BULLETIN T-65-23

SUBJECT: MAIN AND BIG END BEARINGS
HERALD AND SPITFIRE

DATE: MAY 6, 1965

PART No.
140111

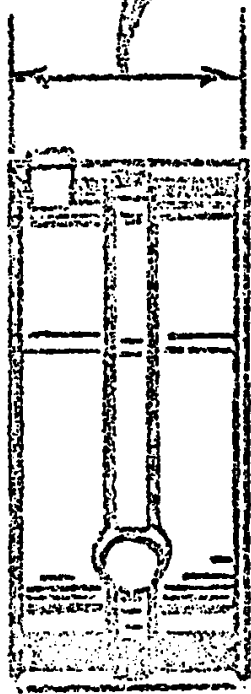
Narrower width main bearings, part number 140111, were introduced at the following ENGINE NUMBERS:

This was followed by narrower width big end bearings, part number 138211, at ENGINE NUMBERS:

Any replacements for engines after these numbers MUST be of the narrower type.

Earlier engines may be serviced with either narrow or original type of bearings.
